**ADDENDUM NO. 1**

**March 8, 2024**

CEDAR KEY  
SANITARY SEWER  
LIFT STATION  
REHABILITATION

C-105

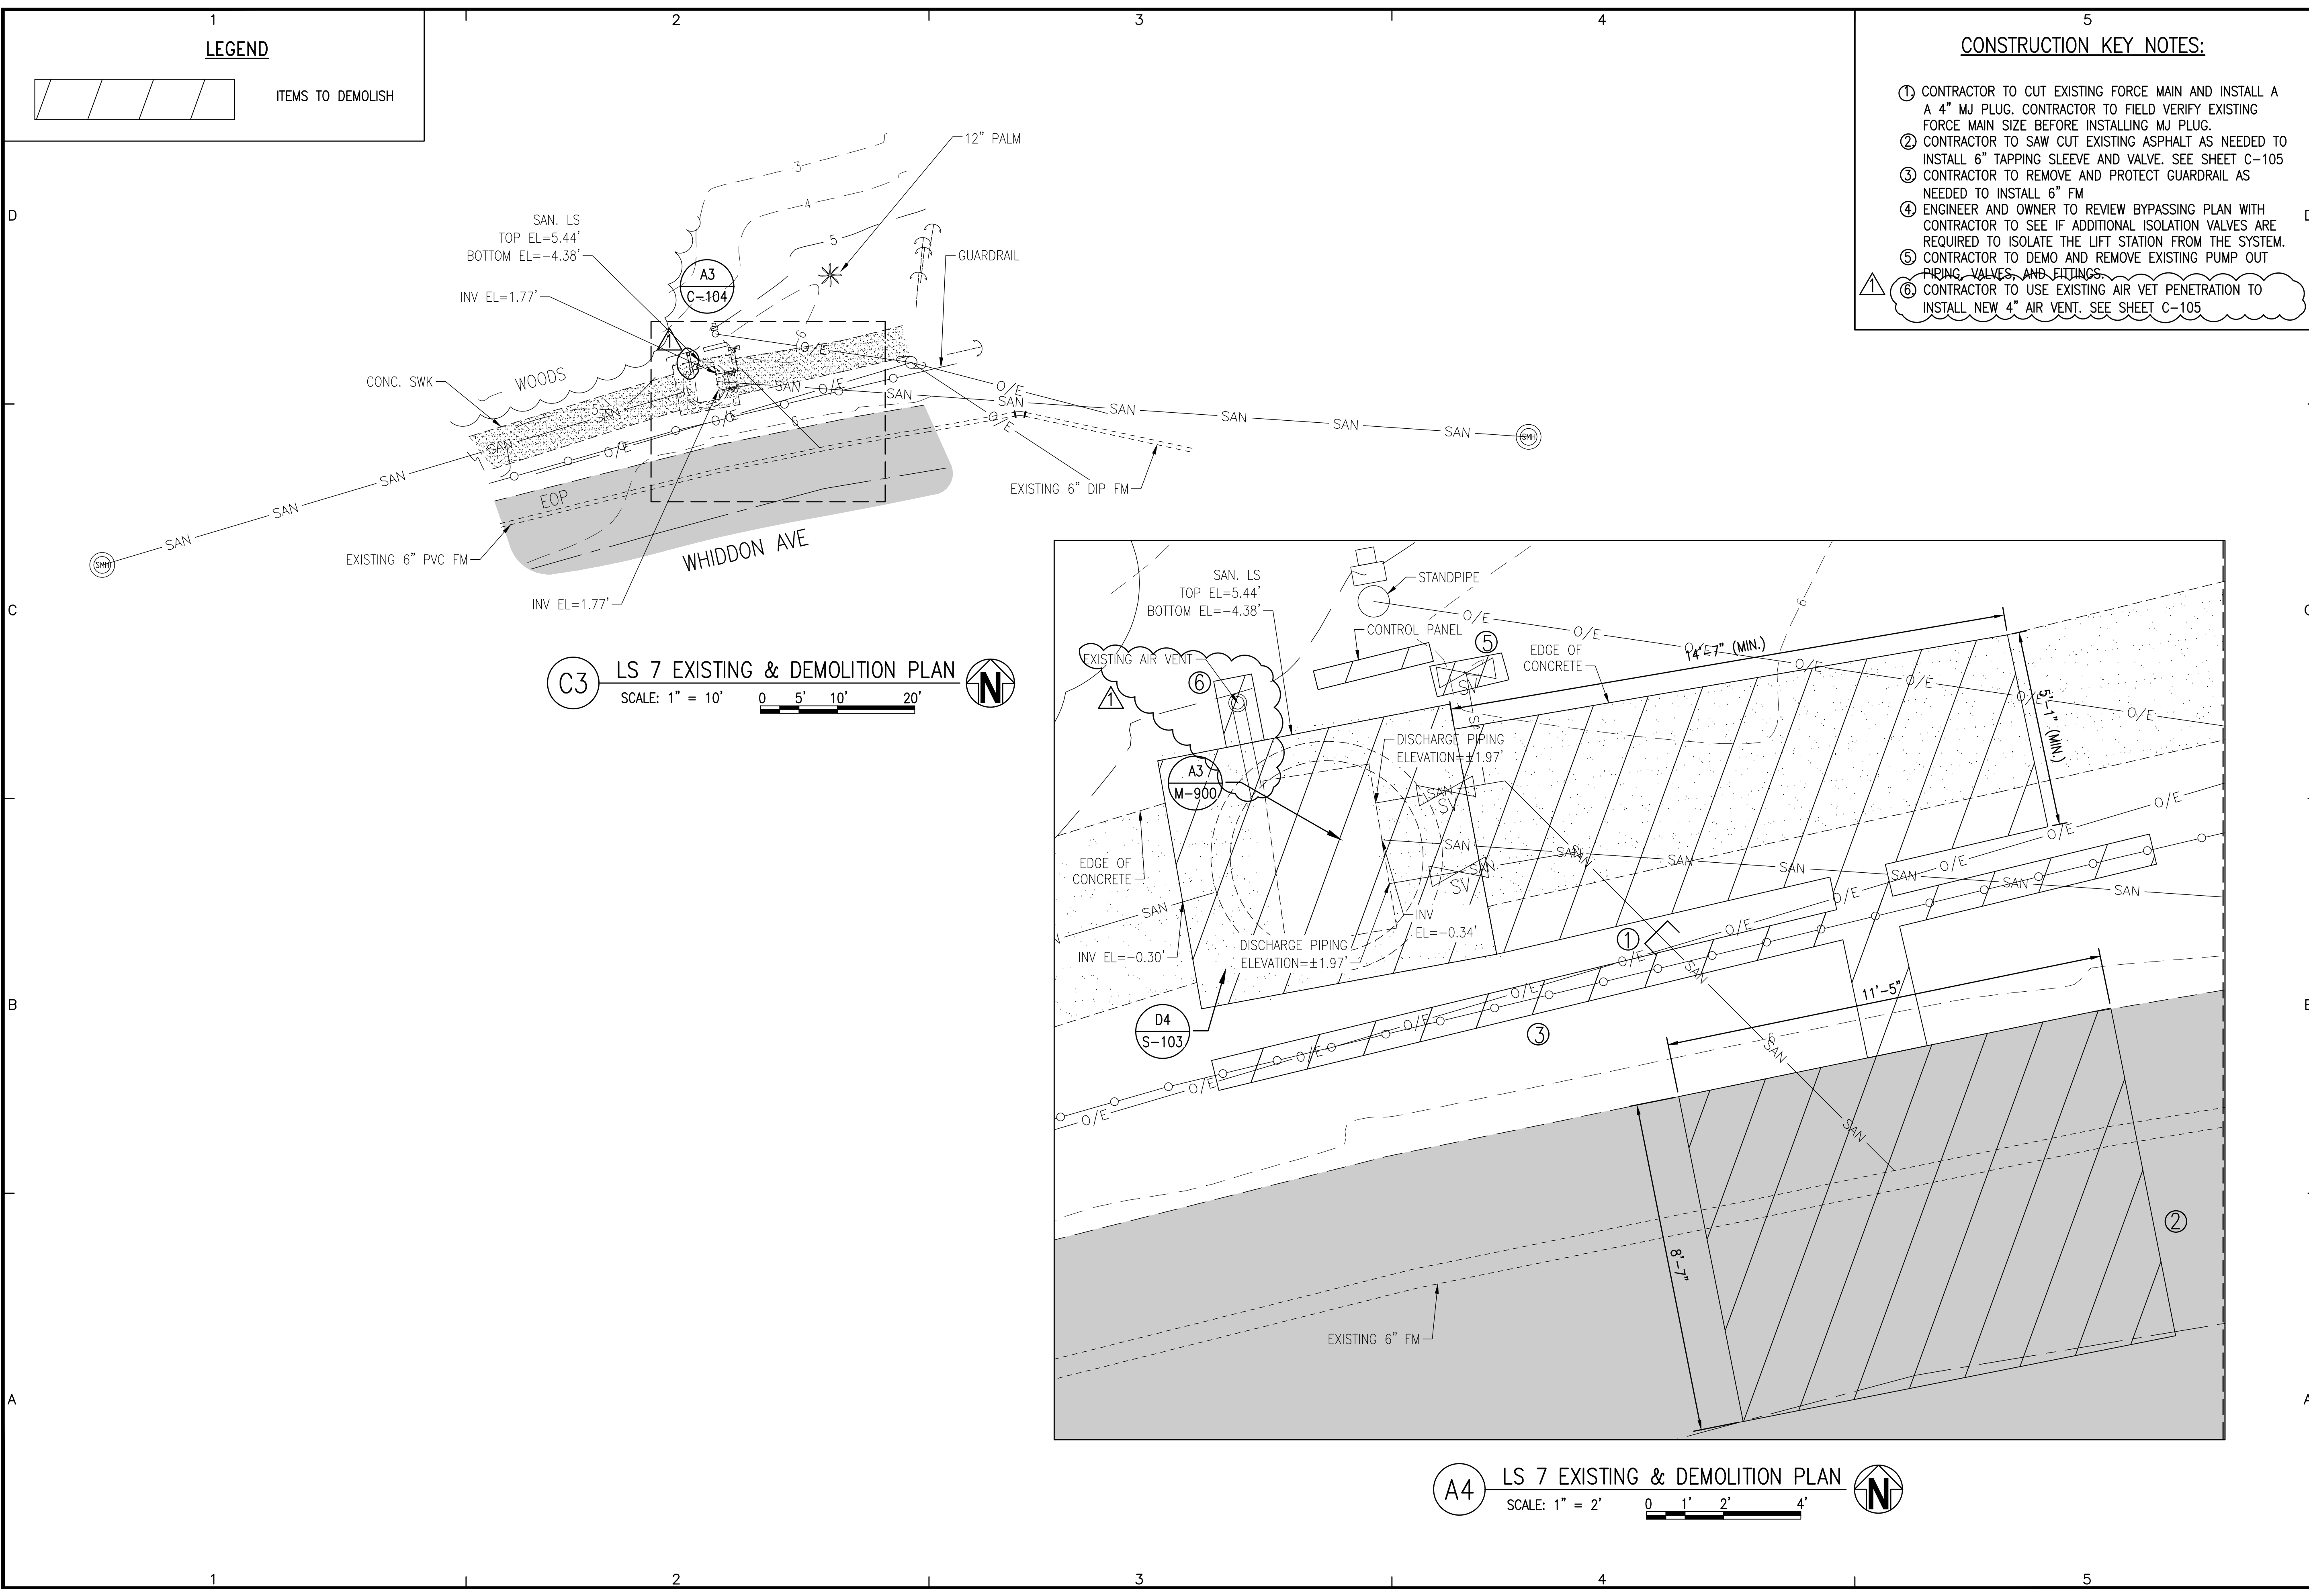
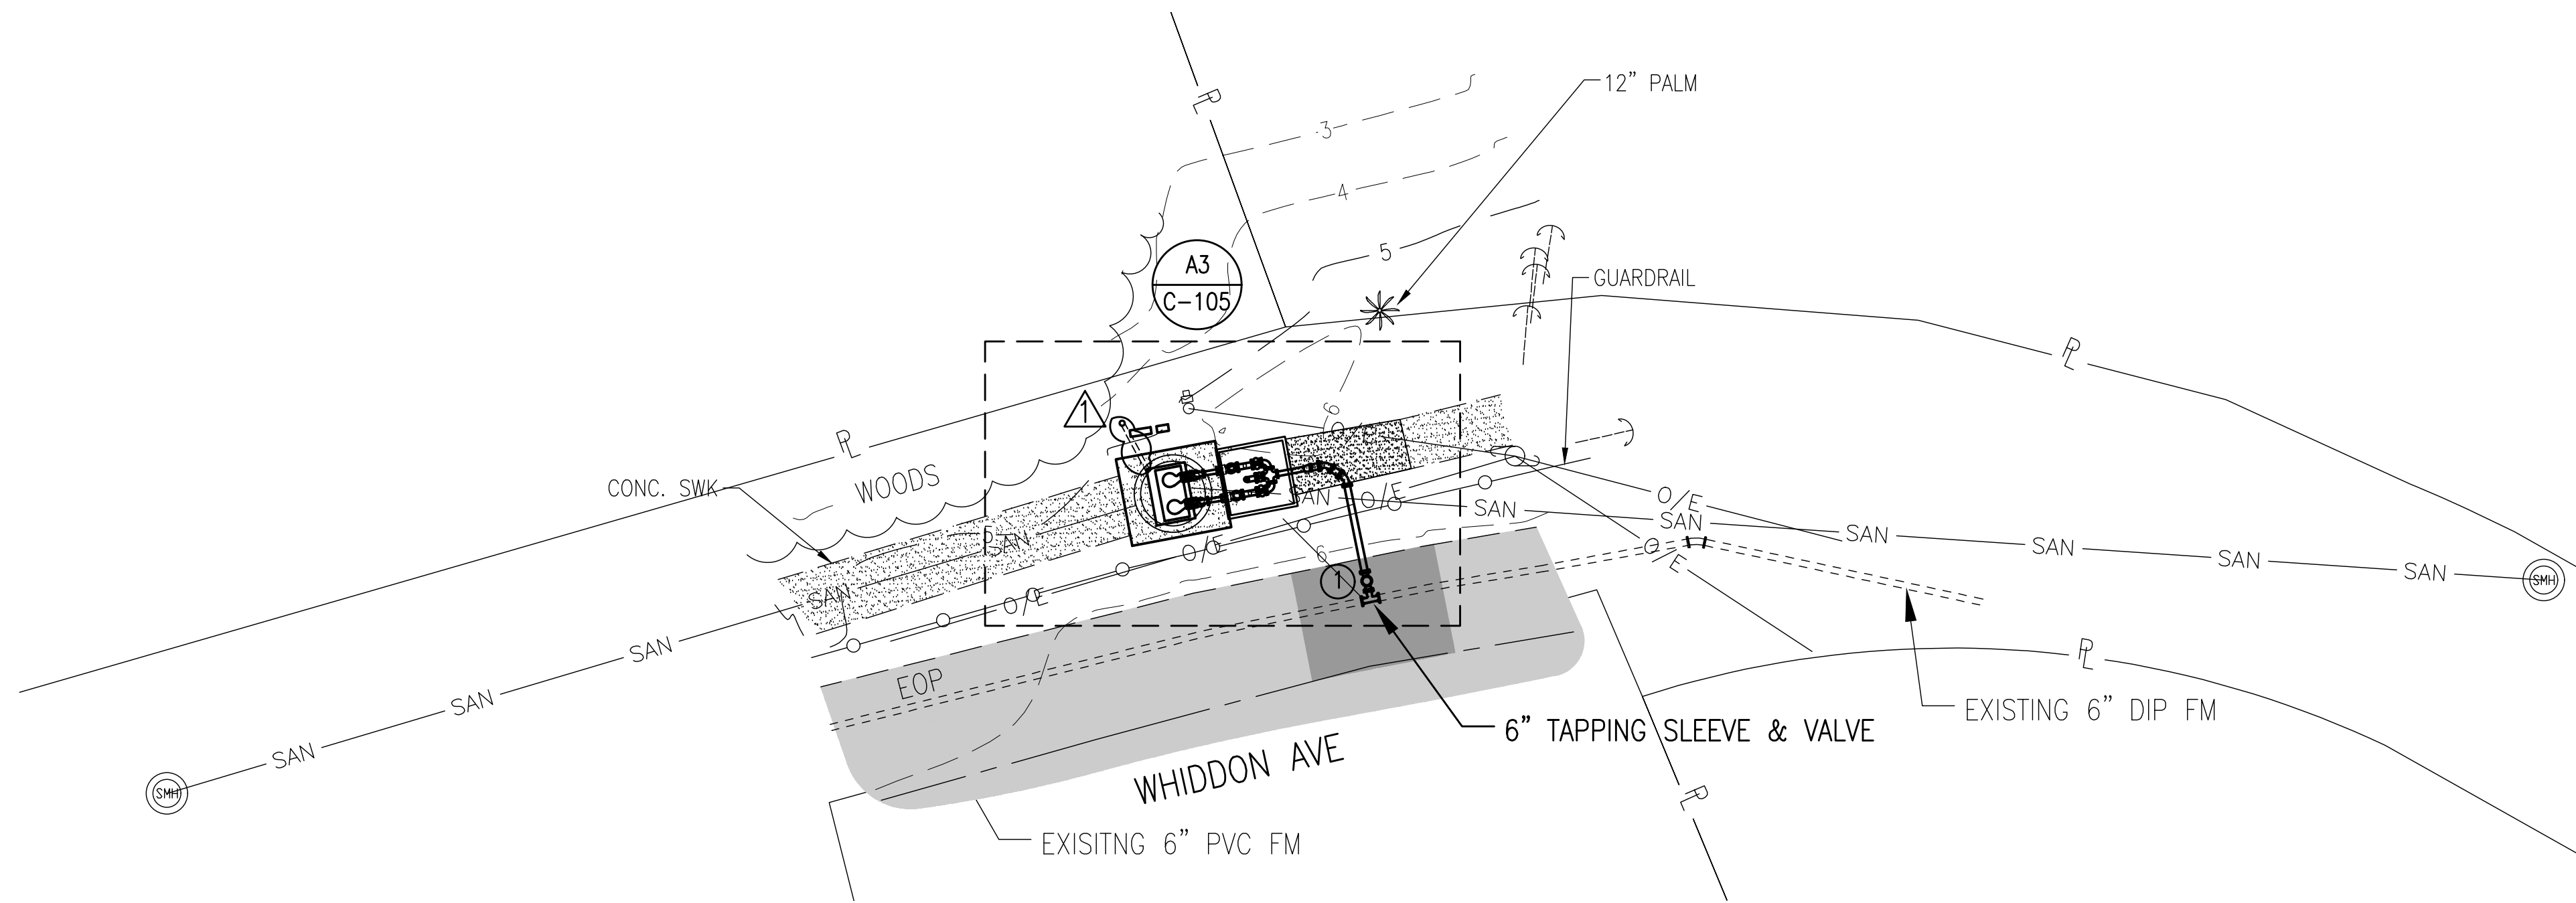
<b>SHEET NO.</b>	<b>CHANGE</b>
C-103	Updated drawing to include three (3) Removable Traffic Rated Bollard. The proposed fence was removed and the proposed gravel for the site was updated accordingly. The Contractor is required to install an emergency contact sign at the Lift Station 6 site.
C-104	Updated drawing to include a Demolition Hatch for the removal of the Existing Air Vent
C-105	Updated drawing to include 4" SS Air Vent to Lift Station 7
C-900	Updated drawing to include an Emergency Contact sign at each lift station site. The Contractor is required to install the emergency contact sign at Lift Station 6 too.
C-902	Updated drawing to include Removable Locking Bollards Detail
M-901	Updated drawing to include the correct pump HP requirements and updated the Emergency Shutoff Level
M-902	Updated drawing to include 4" SS Air Vent to the Lift Station 7 Detail and Updated the Emergency Shutoff Level
